Village of Bayside
9075 N Regent Road
Architectural Review Committee Meeting
June 5, 2023
Village Board Room 6:00pm

**ARCHITECTURAL REVIEW COMMITTEE
AGENDA**

VILLAGE CODE REVIEW

proposed fence

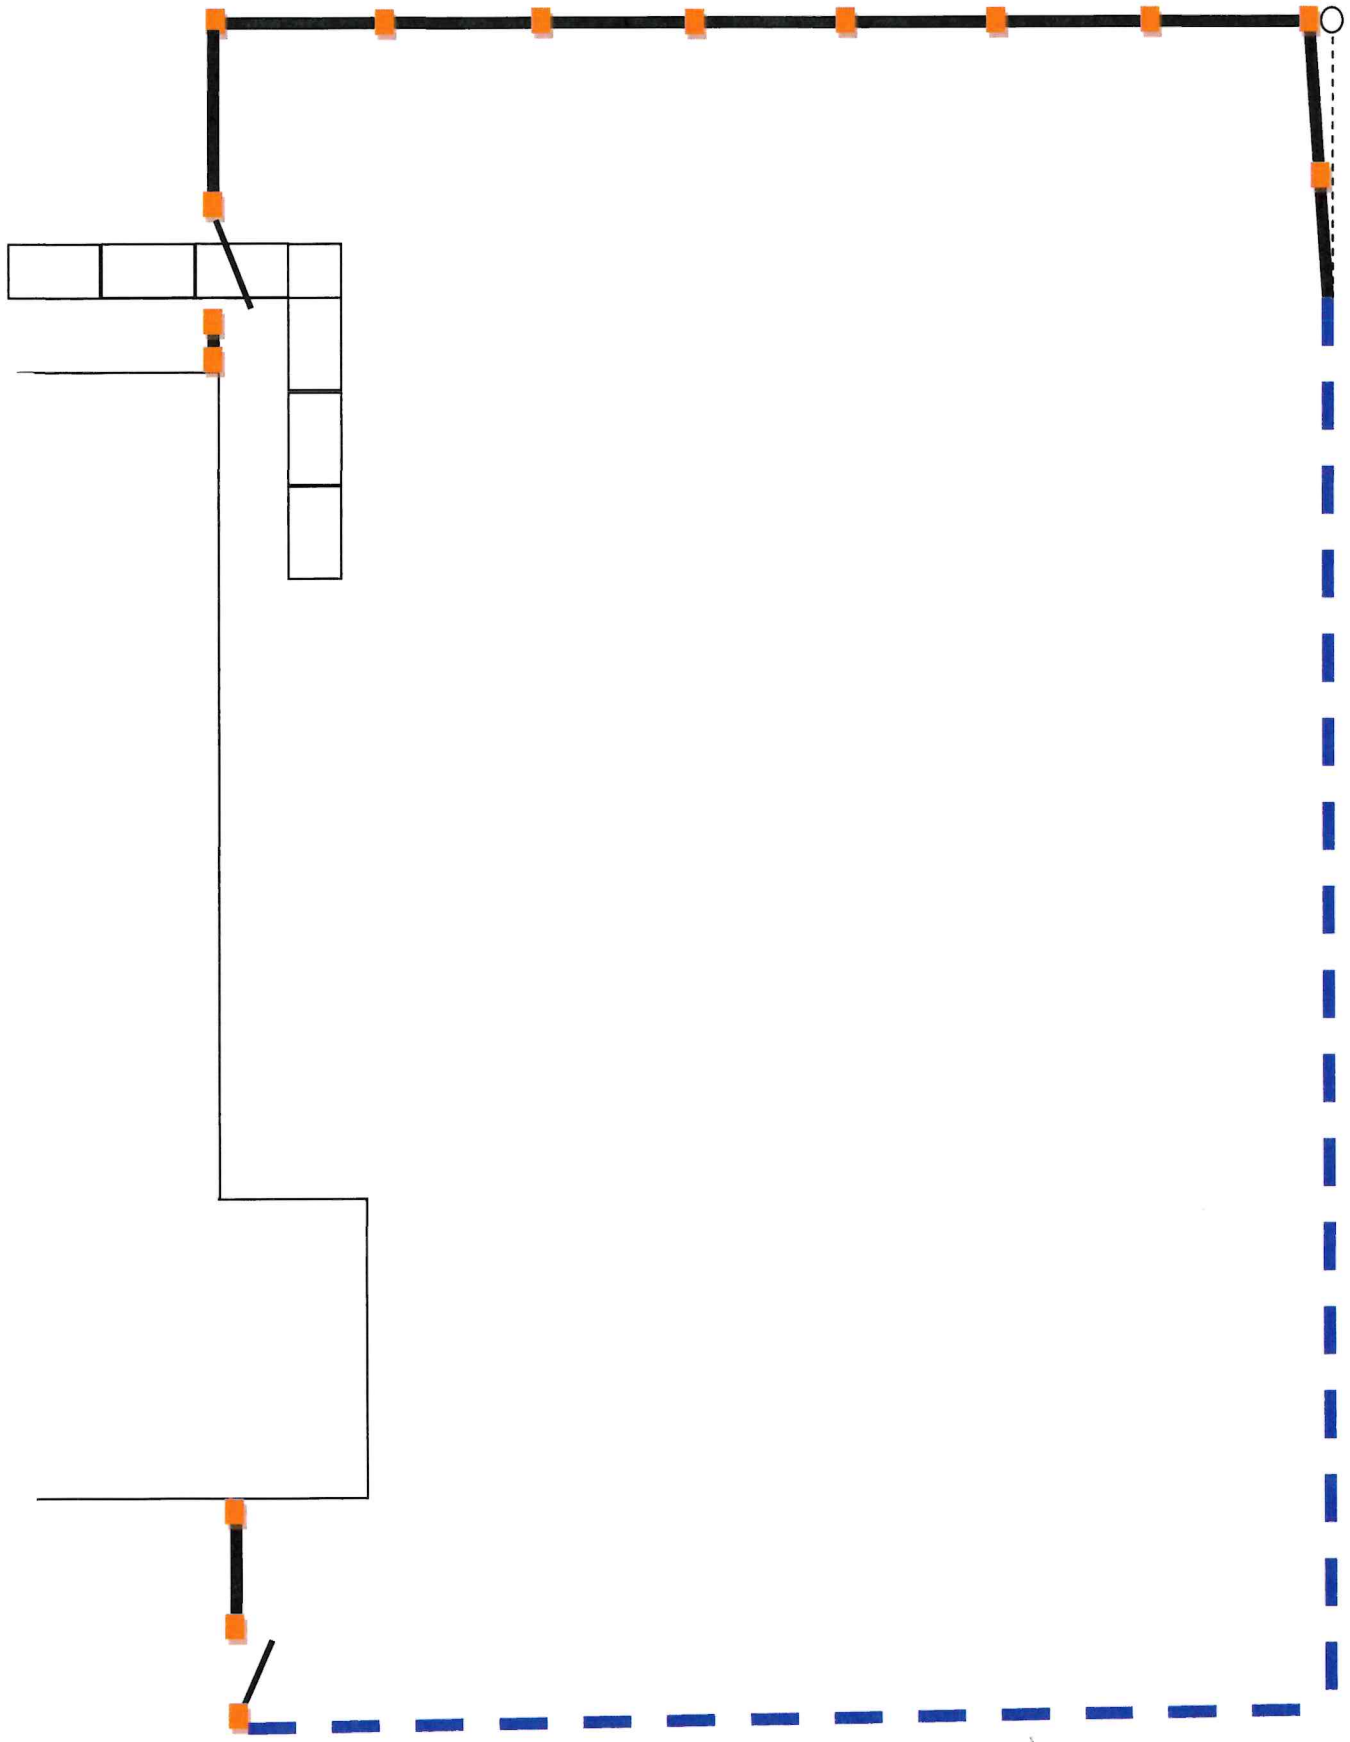
1. They need to adhere to a spacing of two and three quarters of an inch between boards to be compliant with the 50% open design ordinance.
2. A current survey was provided.
3. The board always considers matching fences with neighboring fences.

Per our telephone conversation, I believe I understand what the request is. As I explained we will replicate the neighbor's fence and there will be 2 and 3 quarter to 3 inches of distance between each board to make sure that the fence on the south side and front matches my neighbor's fence to the north which meets that standard as the pictures I sent you show.

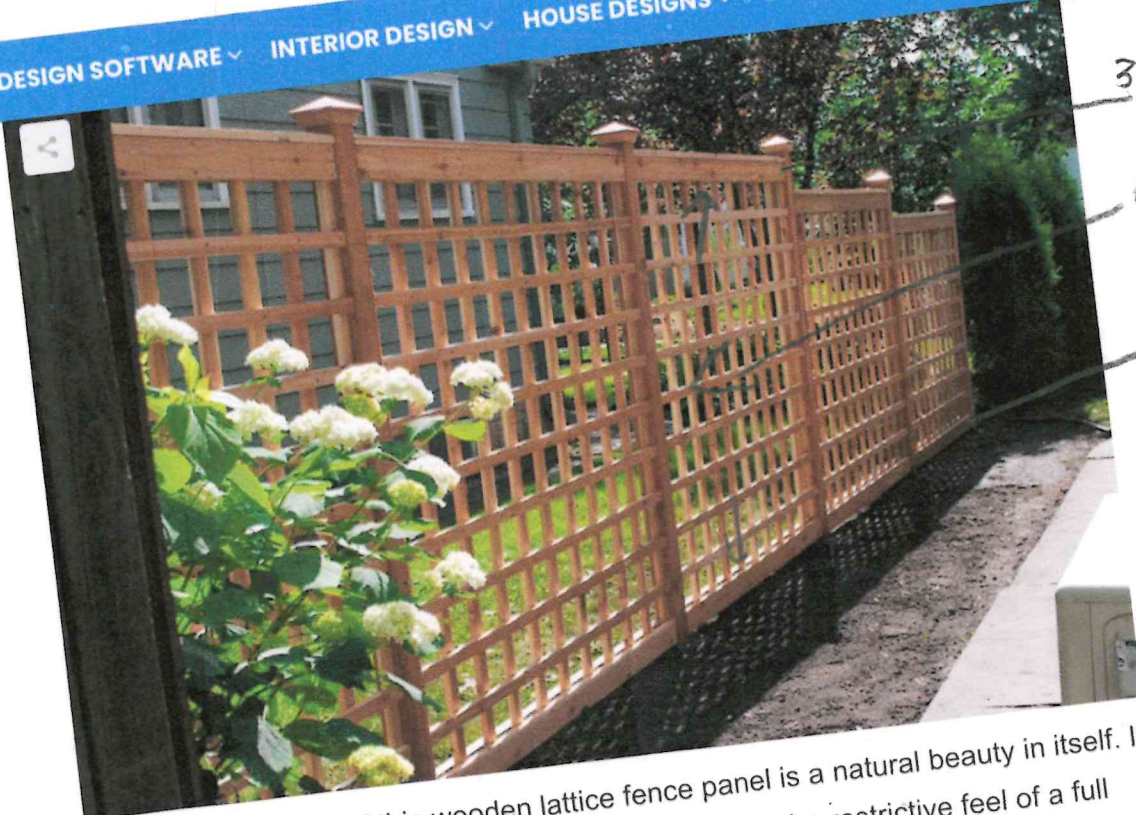
1. With the fence design being open lattice, this complies with the 50% open design requirement in the ordinance.
2. The board always considers matching fences with neighboring fences.

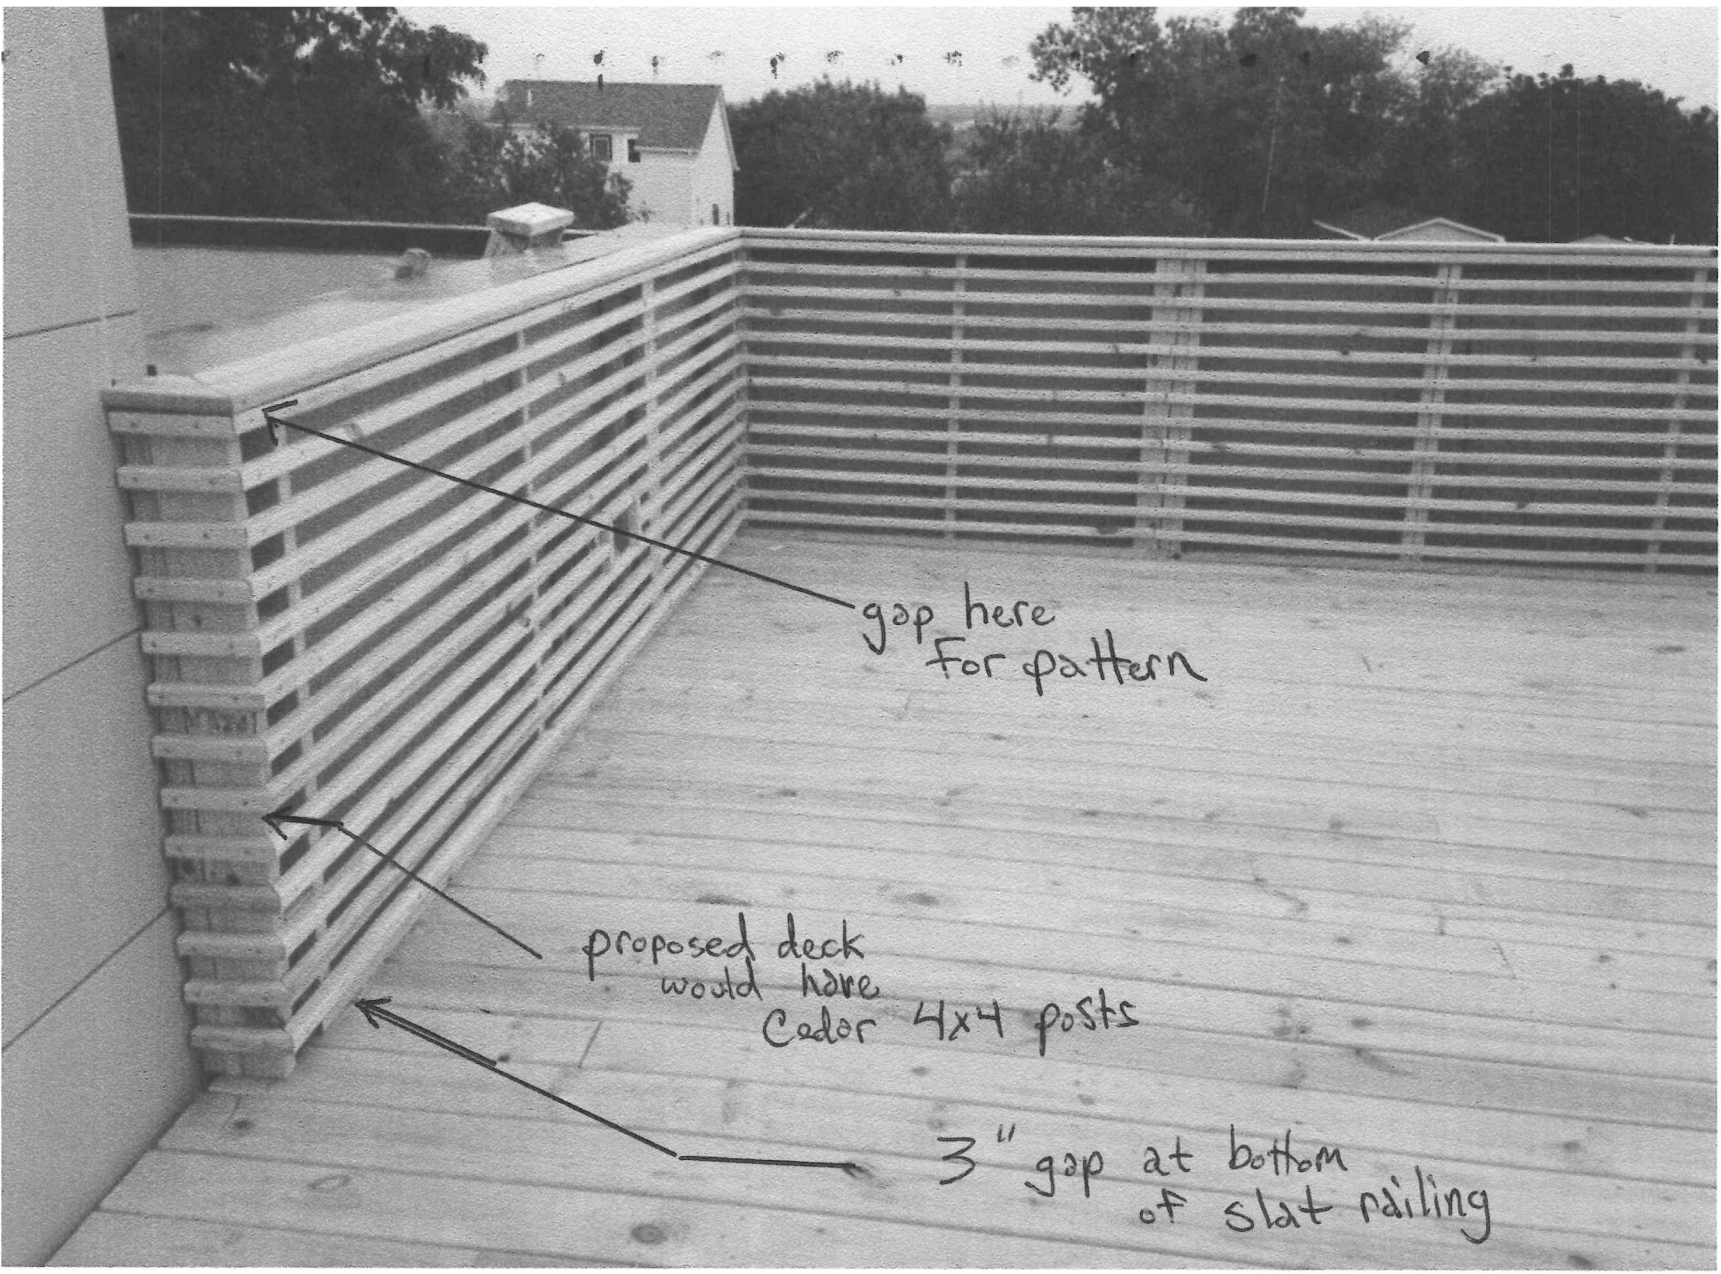
The deck is within the required set backs

There are no issues with this application.

Concept Design
Date: April 28, 2023
Scale: Not to Scale
Integrity
Landscape Services, LLC
(414) 423-7900 (262) 784-1184
www.integritylandscapeservices.com

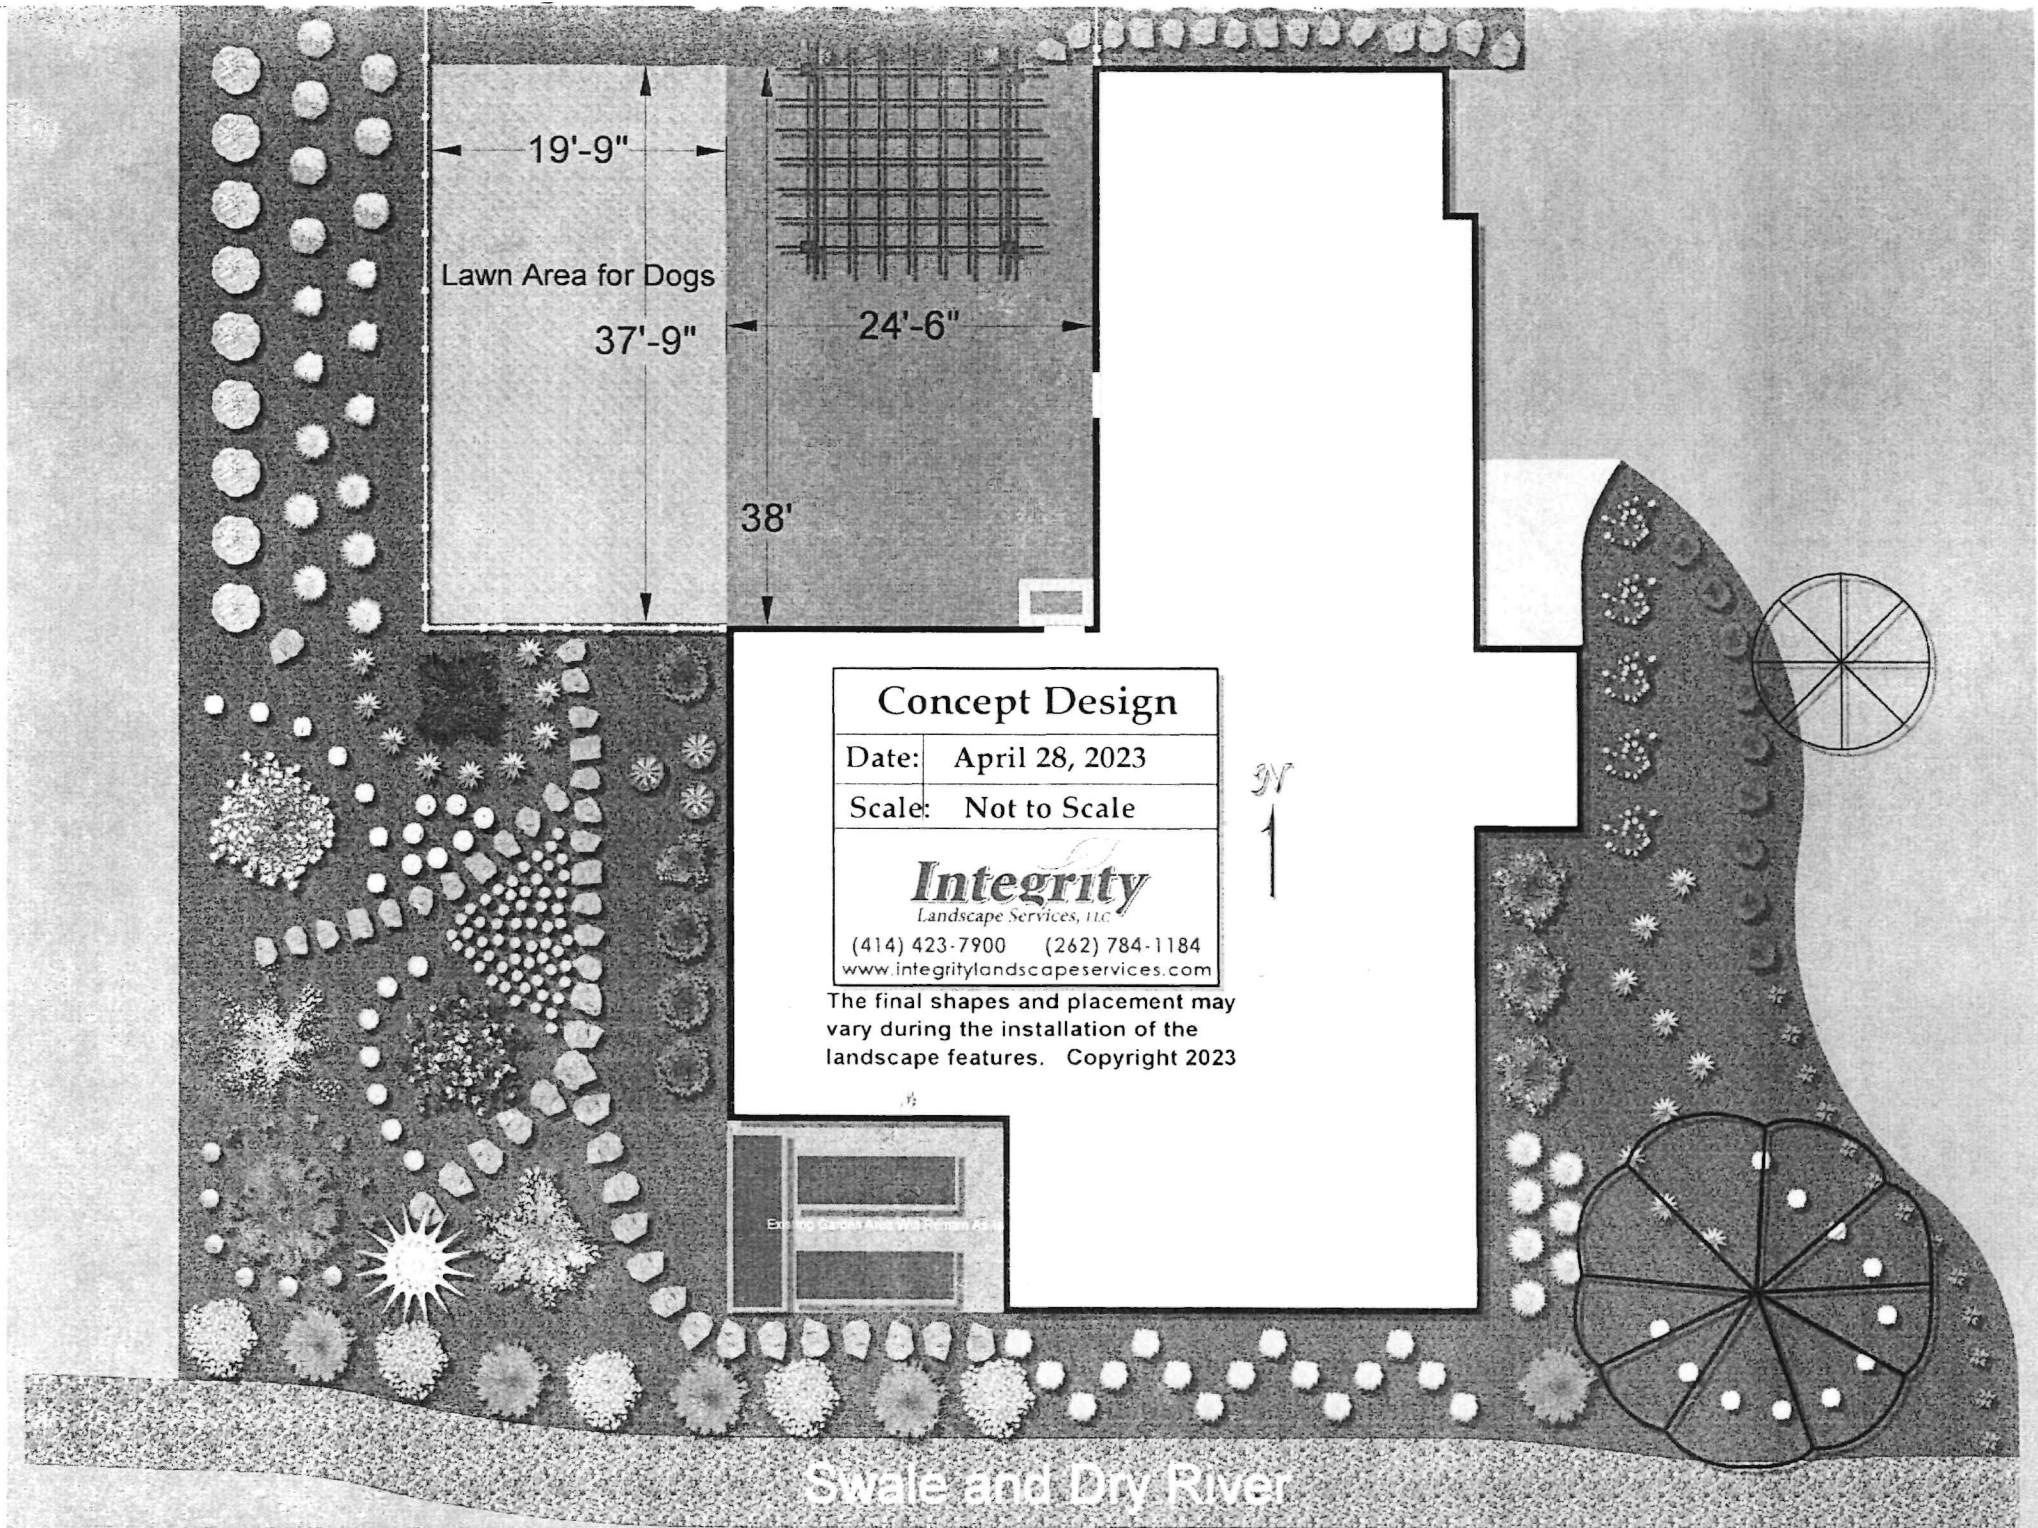
1. The 4-foot-high fence design having face panels of two inches wide with 2 inches of separation, complies with the 50% open design requirement in the ordinance.
2. The 6-foot high by 24' 6" privacy fence complies with the requirements of the ordinance.
3. The pergola shown on the drawing complies with the requirement of setback within the ordinance.
4. The board always considers matching fences with neighboring fences.
